10. Noise and vibration

10.1 Summary of comments

FIGURE 10.1

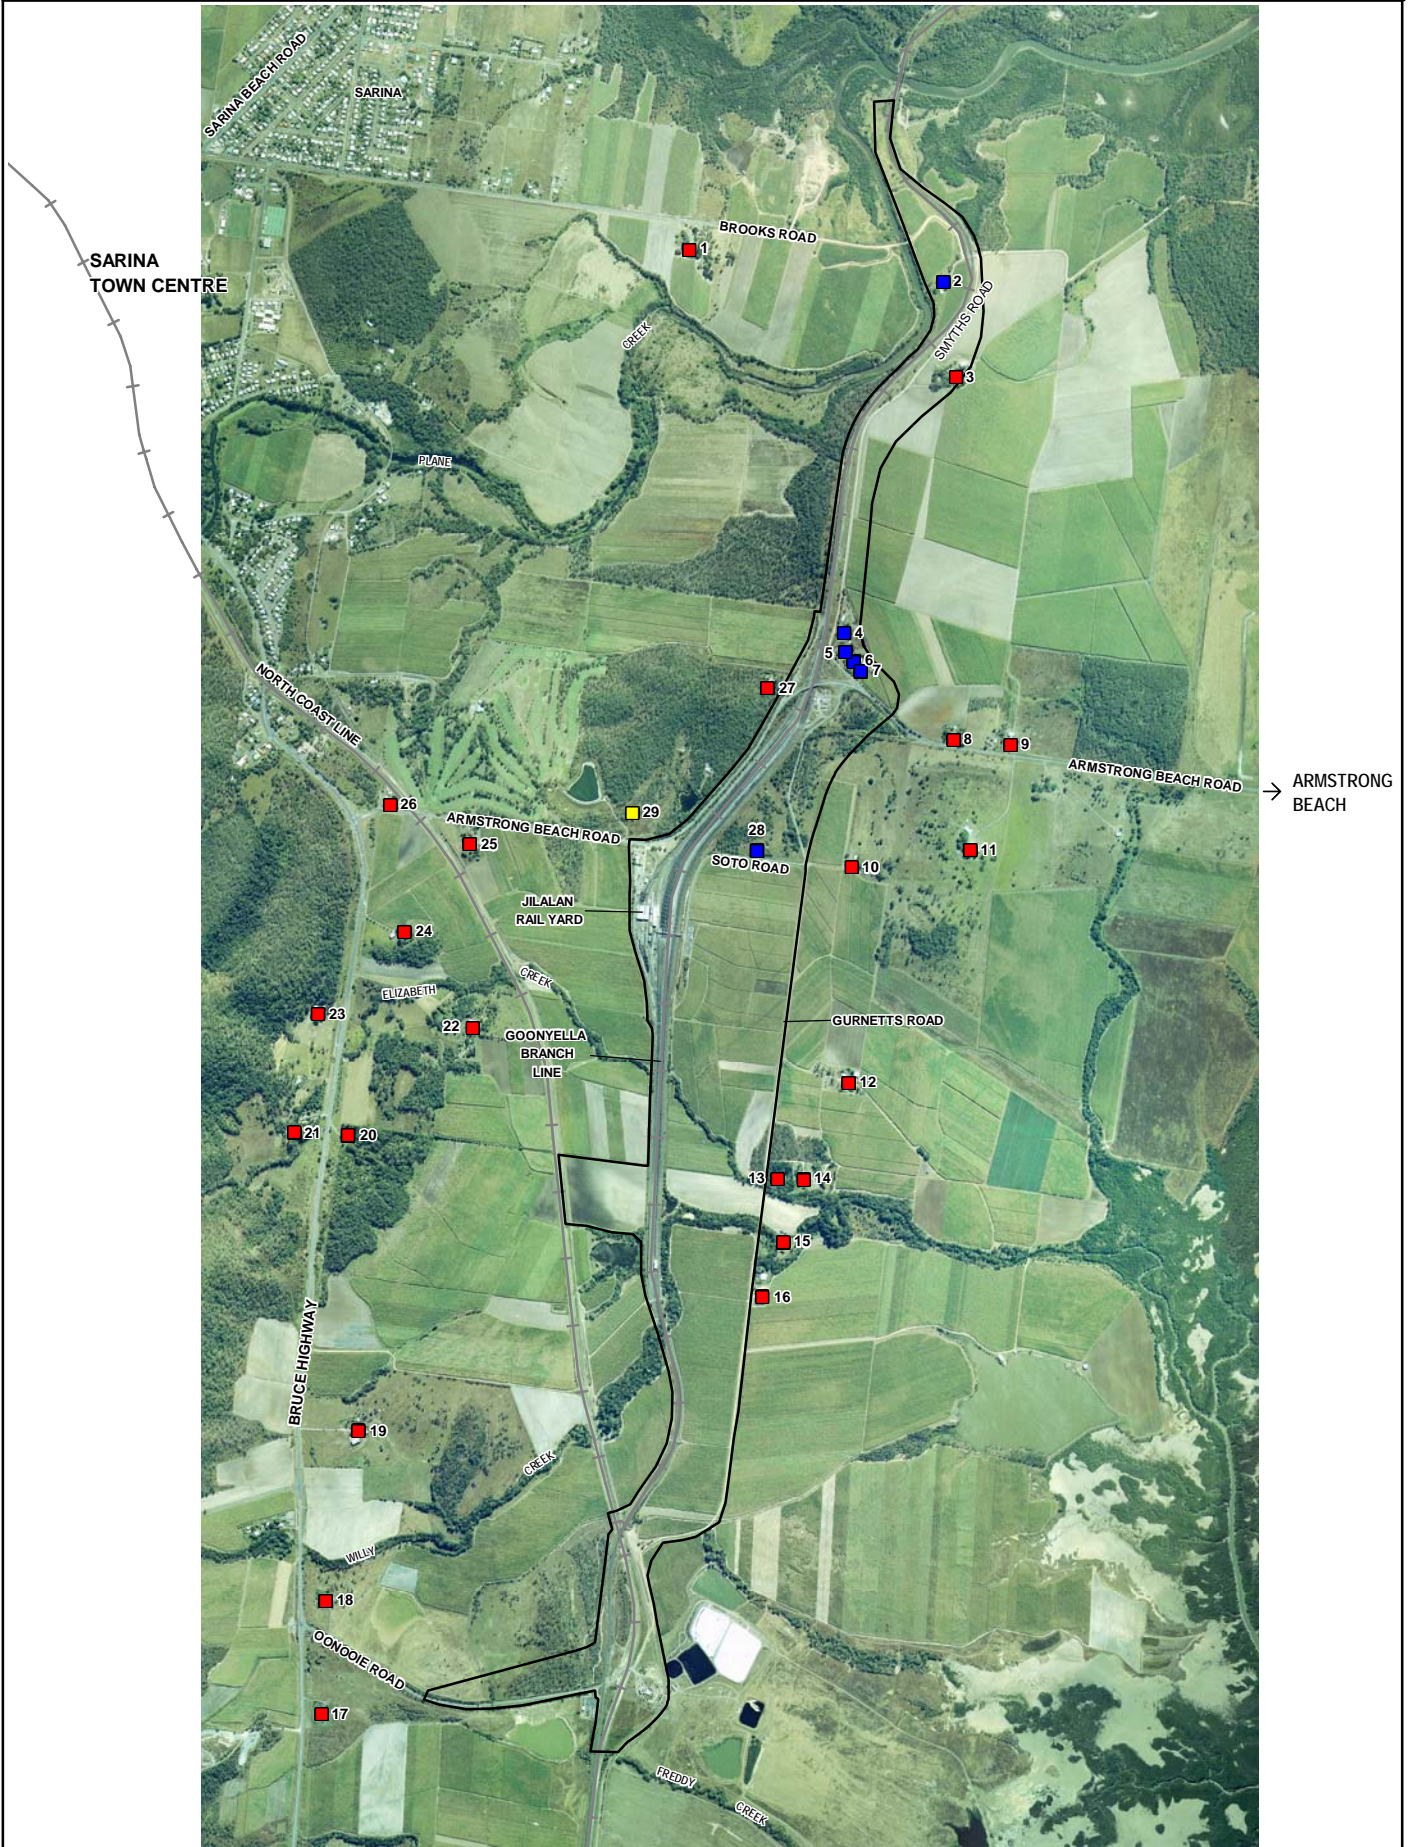
- Noise modelling to be undertaken for the temporary construction workforce accommodation village.
- Clarifying that operational noise monitoring for a minimum period of 48 months (which was undertaken for the DBCT Rail Loop Triplication Project) is not appropriate for the JRYUP.

The location of the construction workforce accommodation village and other residential receivers within and/or adjacent to the project area are shown in Figure 10.1. Noise levels for both construction scenarios have been predicted at nine representative receivers for neutral weather conditions. The predicted noise levels are summarised in Table 10.1. The predicted noise levels assume that no special mitigation measures have been employed to limit noise emissions (eg enclosures around compressors).
